# CONSERVATION COMMISSION AGENDA

The Conservation Commission will hold this meeting as a virtual meeting on Thursday, August 6, 2020 at 7:00 pm. No in-person meeting will take place at City Hall.

#### 1. Various Locations in Newton – RDA – herbicide spraying along commuter rail

# WETLAND RESOURCE AREAS ALONG COMMUTER RAIL

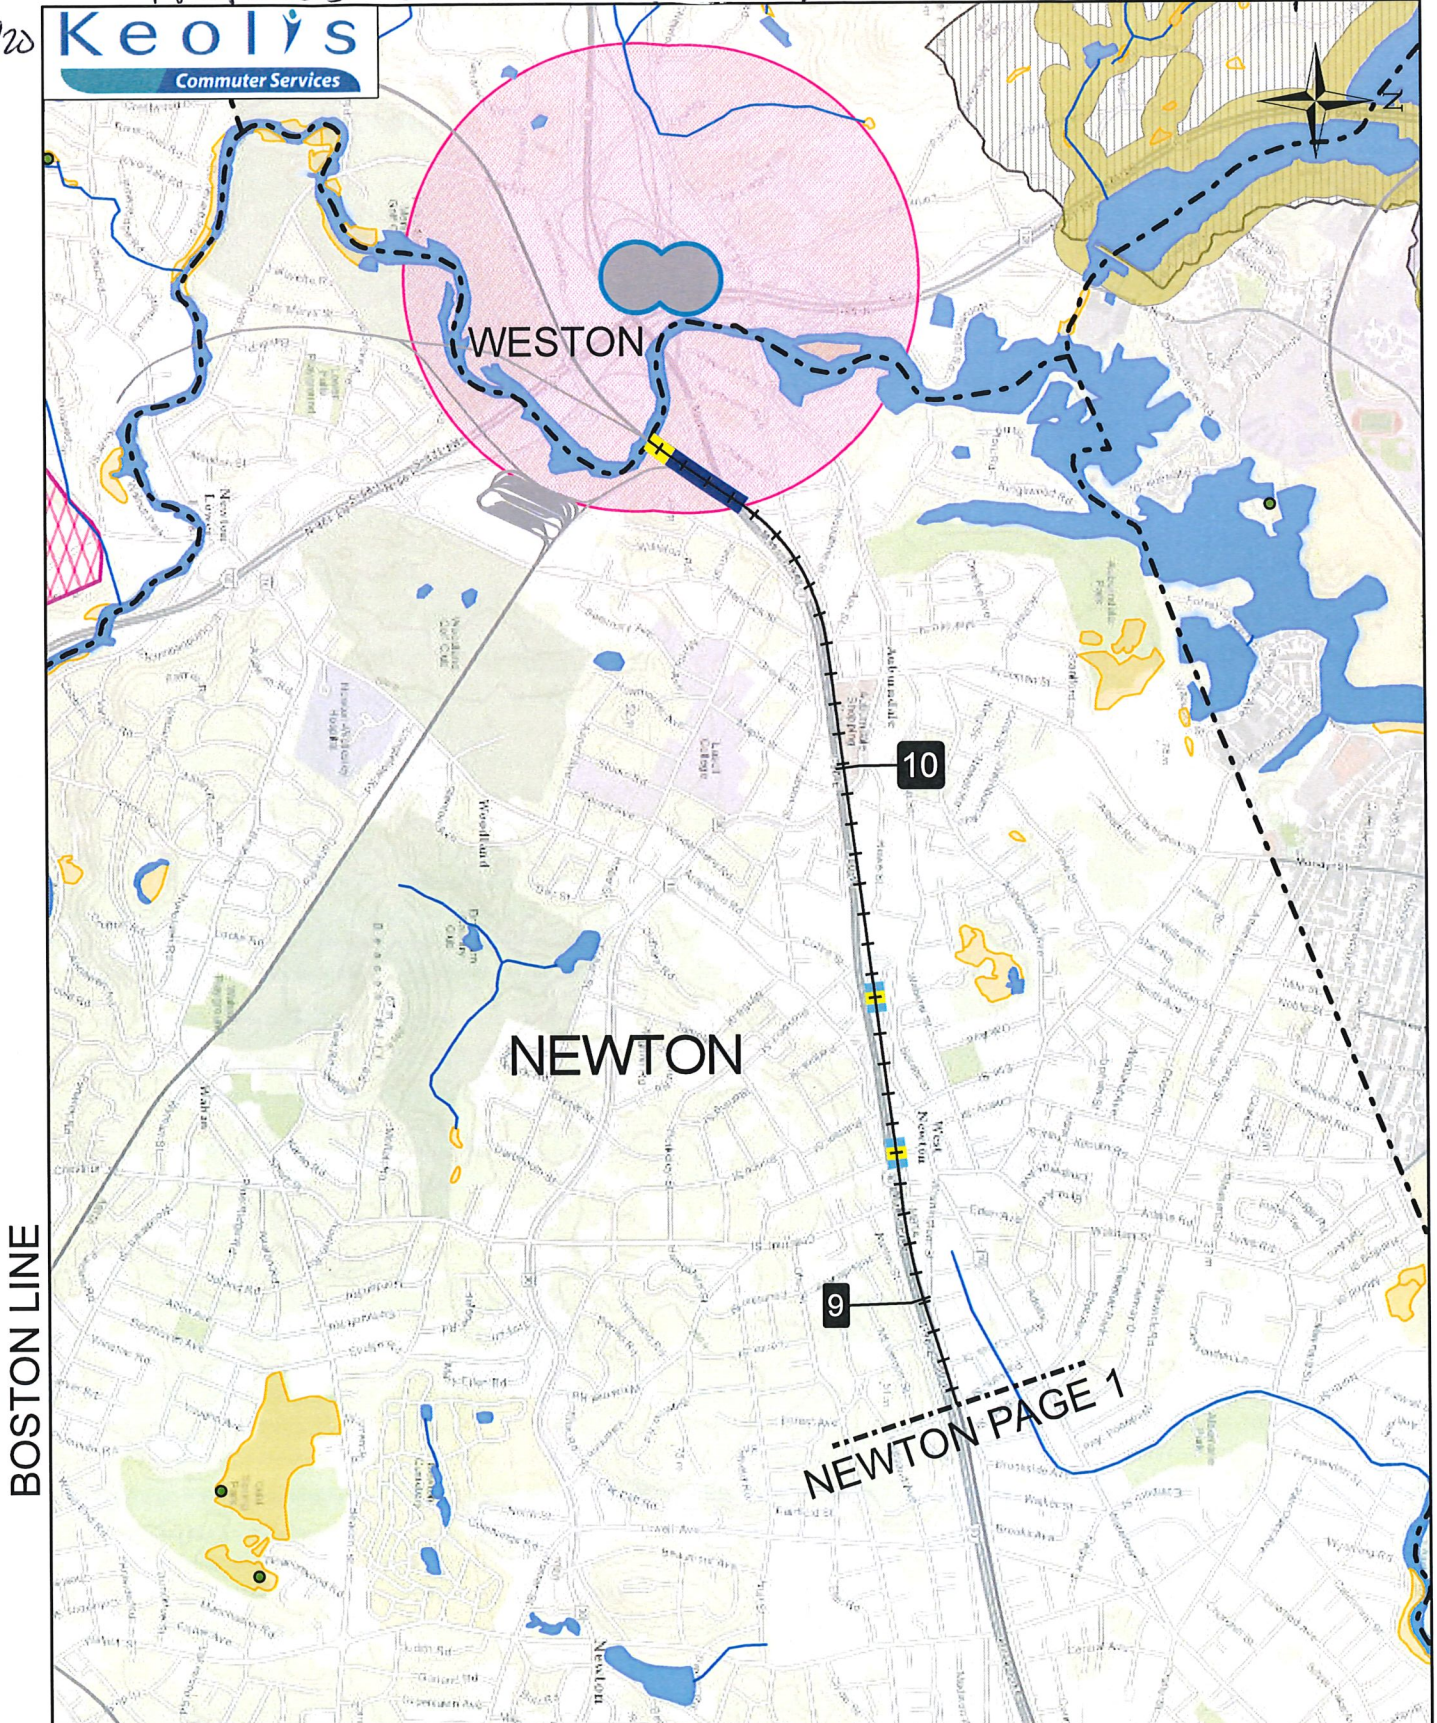
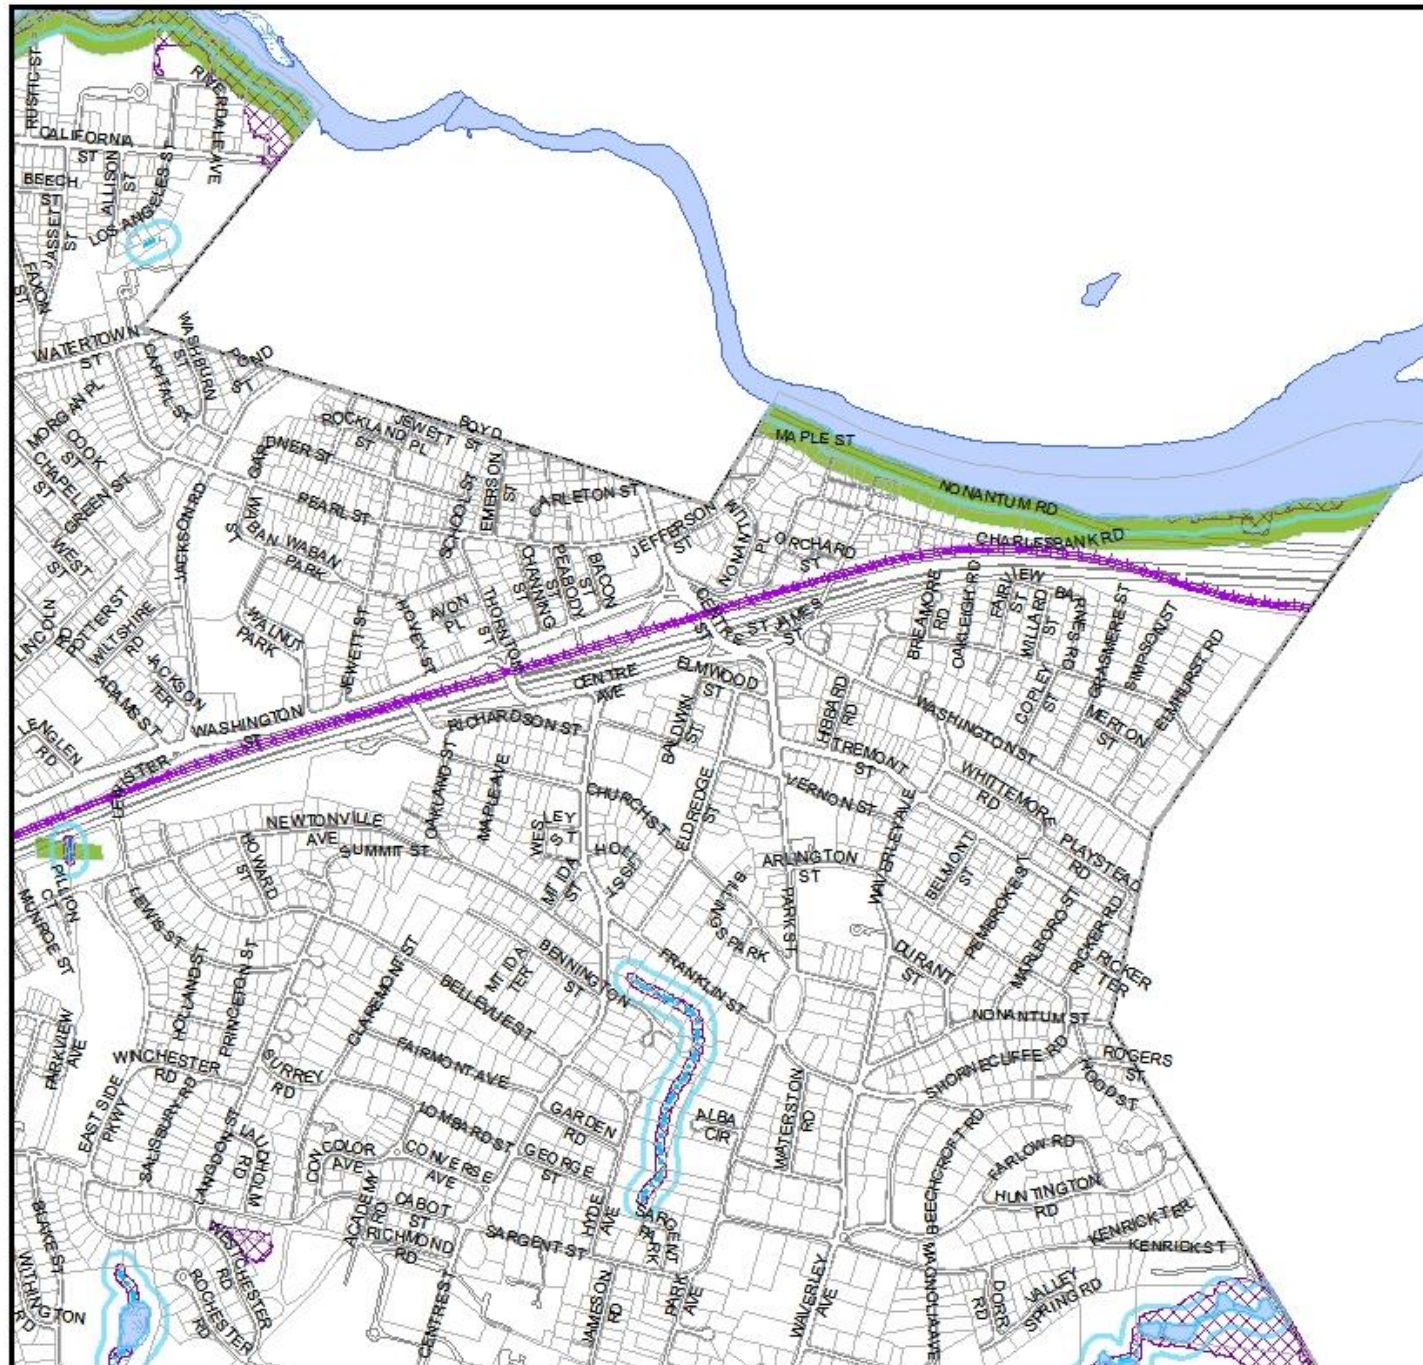
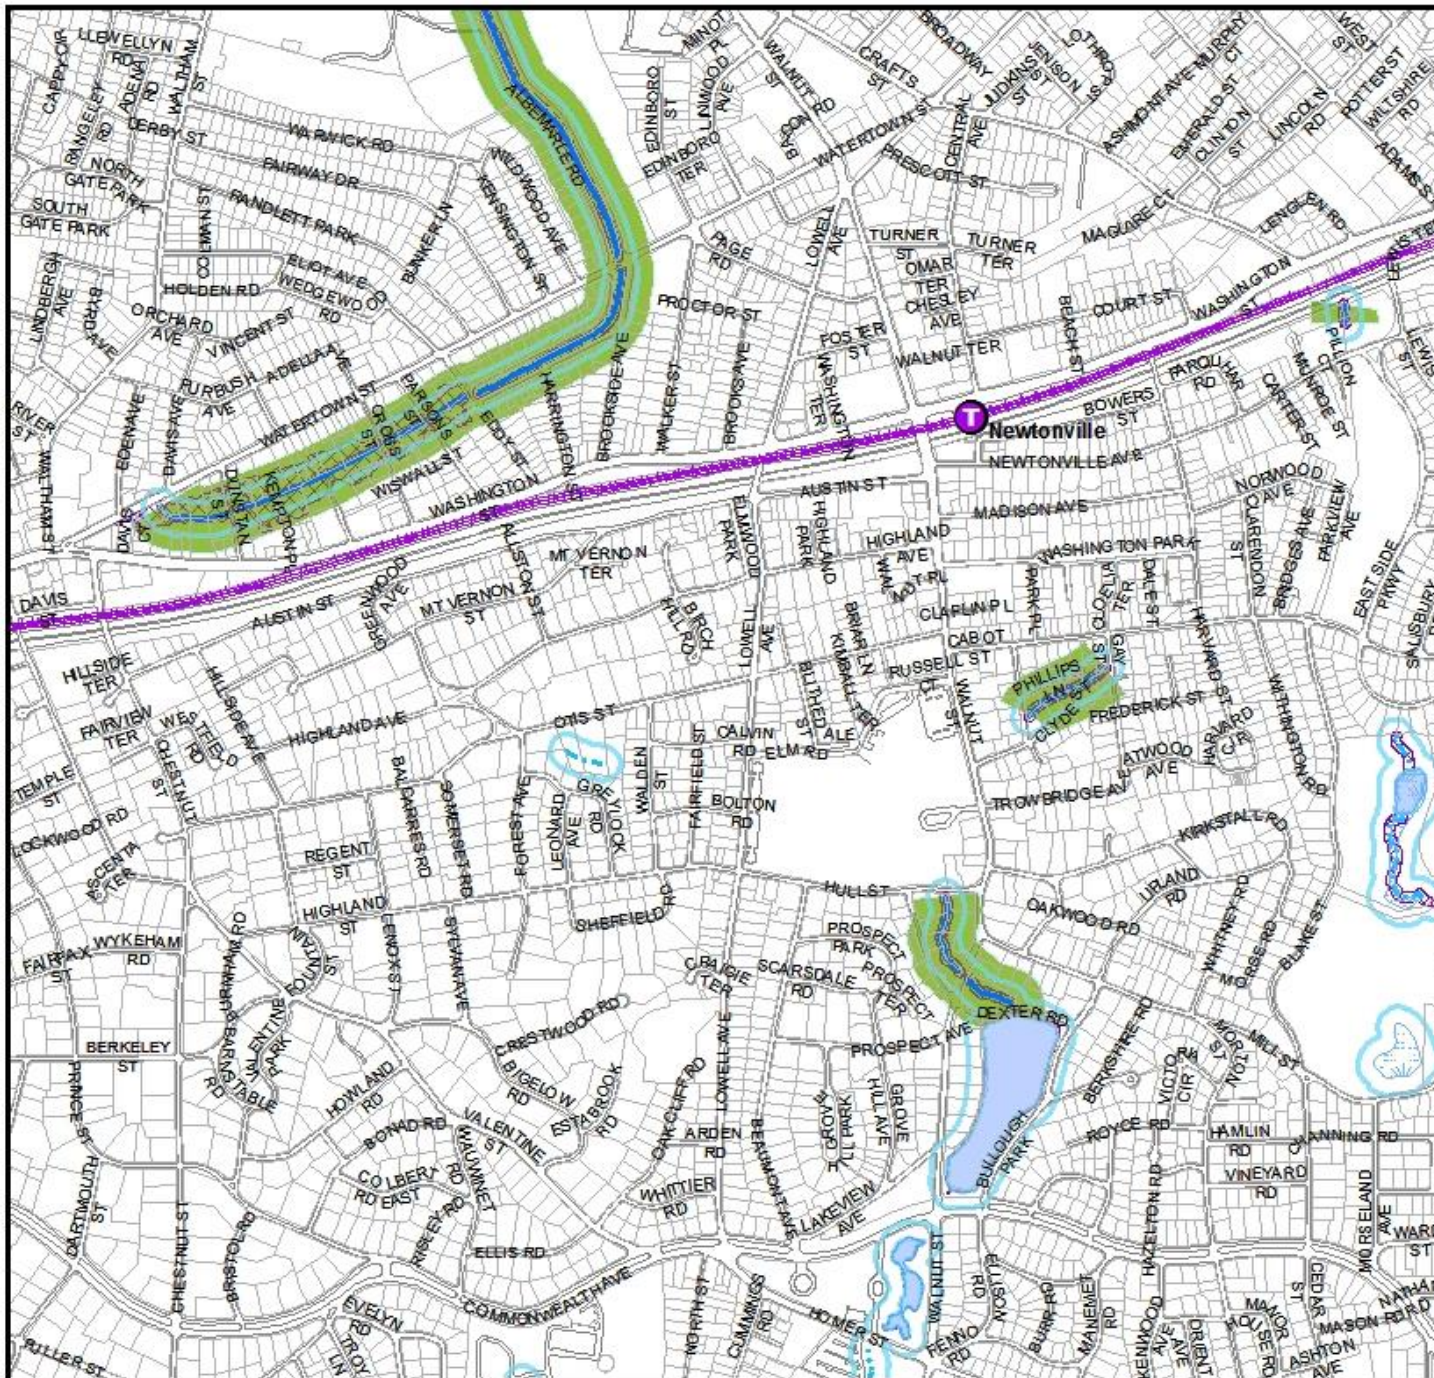
- Staff Notes
  - Inaccuracies of the application:
    - The applicants claim of exemption under 10.02(2)(a)(2) is incorrect -- railway is not a listed public service.

- The presumption of "no alteration" in 10.03(6)(b) only pertains to buffer zone -- not Riverfront Area.
    - The wetland jurisdictions on the commuter rail line are Buffer Zone and Riverfront Area. All other "sensitive" areas shown on the plans are not wetland jurisdiction.

- Conclusions
    - The maps should be corrected to show only the Riverfront Area
    - The DOA should approve the revised maps (as required by under 333 CMR 11.00).

- The DOA should reference the following exemptions:
      - 10.03(6)(b) Any application of herbicides within the Buffer Zone, other than as provided in 310 CMR 10.03(6)(a), shall be presumed not to alter an Area Subject to Protection under M.G.L. c. 131, § 40, only if the work is performed in accordance with such plans as are required by the Department of Food and Agriculture pursuant to 333 CMR 11.00: Rights of Way Management, effective July 10, 1987. This presumption shall apply only if the person proposing such activity has requested and obtained a determination of the boundaries of the Buffer Zone and Areas

# 24 VILLAGE RD - PROPOSED CONDITIONS

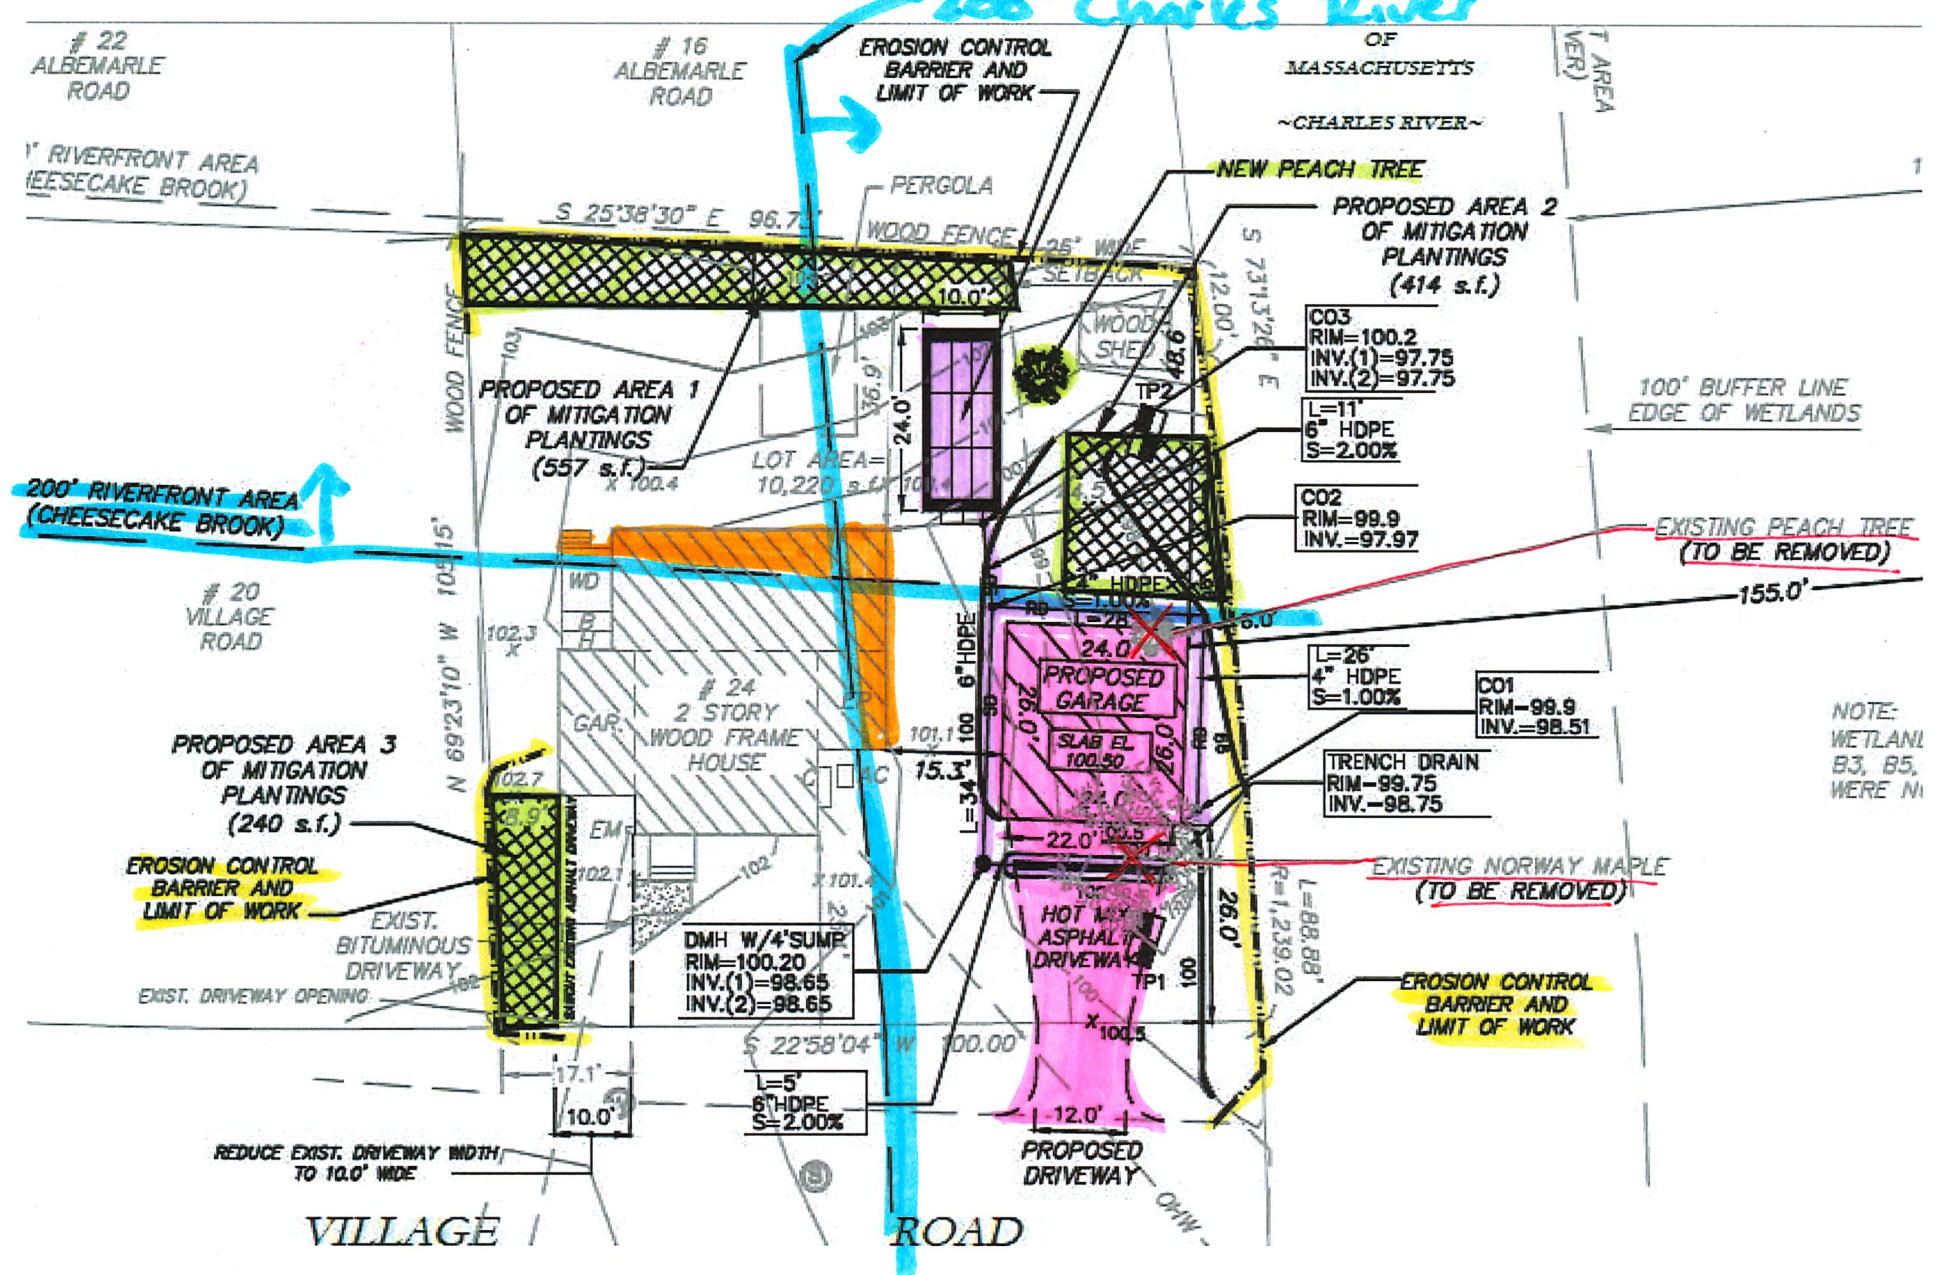
- At the Commission’s request, the applicant has proposed to eliminate half (7’x30’) of the existing driveway and create a mitigation planting bed in its place. (N.B. both are outside ConCom jurisdiction.)

- The total curb cut will now be 22’ (10’ from the existing drive and 12’ from the proposed drive)
  - The erosion control detail has been amended to include staked silt fence and a compost sock.

- Three mitigation beds are now proposed for a total of 1211 s.f. Native plants have been proposed (in addition to some non-native transplants). One “evergreen tree” has been proposed, but not specified in any way.

- Staff Recommendations: Review the revised plans and vote to issue an OOC if it is felt that the intent of the Act and the requirement of “At a minimum, a 100’ wide area of undisturbed vegetation is provided... preserved or extended to the max. extent feasible...” is being upheld.

**PROPOSED SITE PLAN**  
 35 SPIERS ROAD  
 NEWTON, MA 02459  
 SCALE: 1"=10' DATE: JUNE 12, 2020

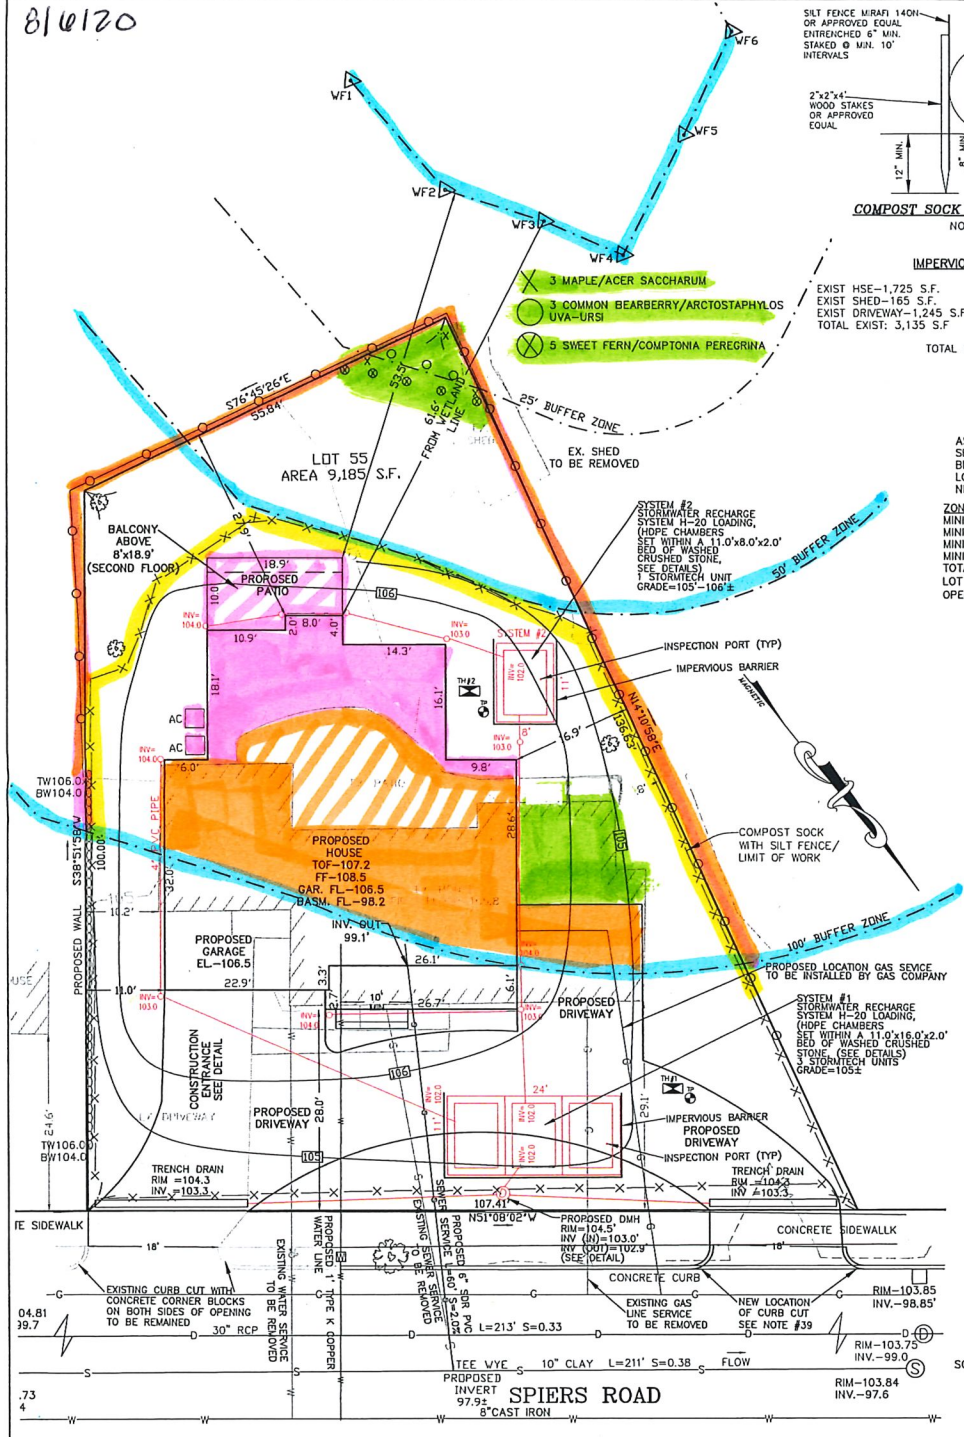
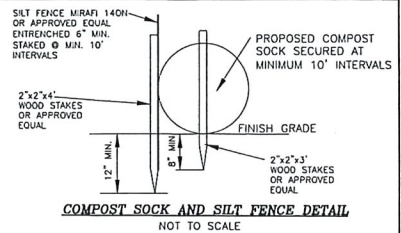
- Staff Notes
  - The limit of work line is unrealistically close to the edge of grading, excavation, and construction.
  - Applicant should clarify if the existing wooden fence is due to be removed and replaced.

- The mitigation planting plan is very dense and small, and all plantings should be done on the subject lot, as the plans appear to show plantings occurring beyond property boundaries.

- There is an existing oak tree in the neighboring lot adjacent to the proposed plantings in the rear corner. It is fairly small and may not impact the growth of the proposed maples, but the location of the southern most maple should be shifted closer to the proposed house to ensure no conflict.

- All landscape plantings must survive two growing seasons at 100%.
  - Any new fence installed on the site must be elevated 6" from the ground to allow for wildlife passage.
